Engineering Note: EN0067 - Modification to Remote Recipe Module

Summary: Changes to Remote Recipe Module
Products affected: Hydro-Control V Remote Recipe Module
Revision Date: 30/09/2010 Author: Neal Cass

Figure 1: The wiring connections for the new module

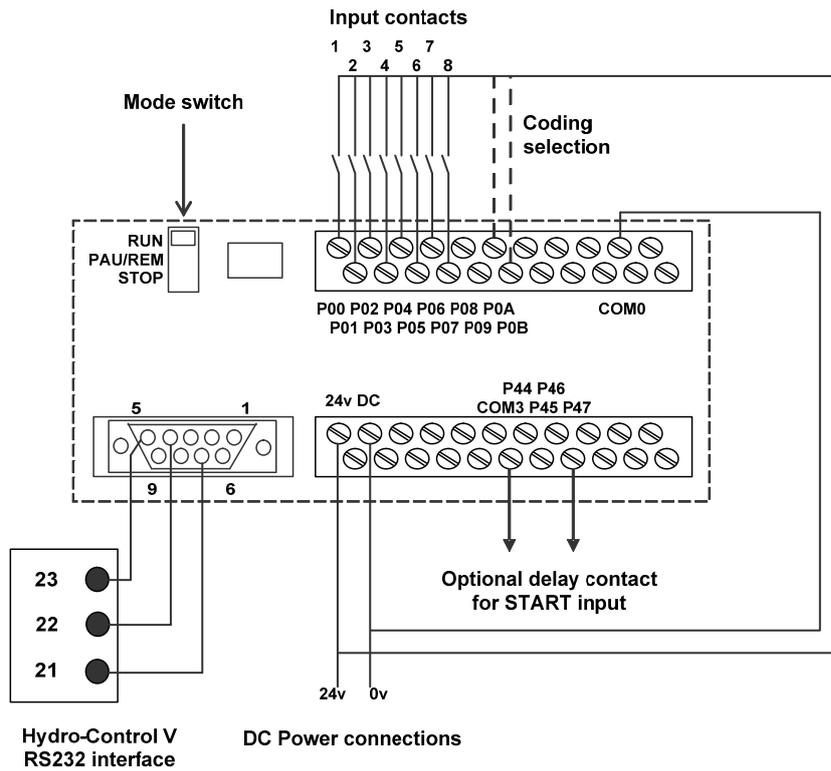
The wiring of the unit has changed when using 24v DC to switch the inputs. The module does not have a 24v DC output so the COM for the Digital Inputs and the 24v for the switch inputs must be taken from the main power to the unit instead. This is shown in Figure 1 overleaf.
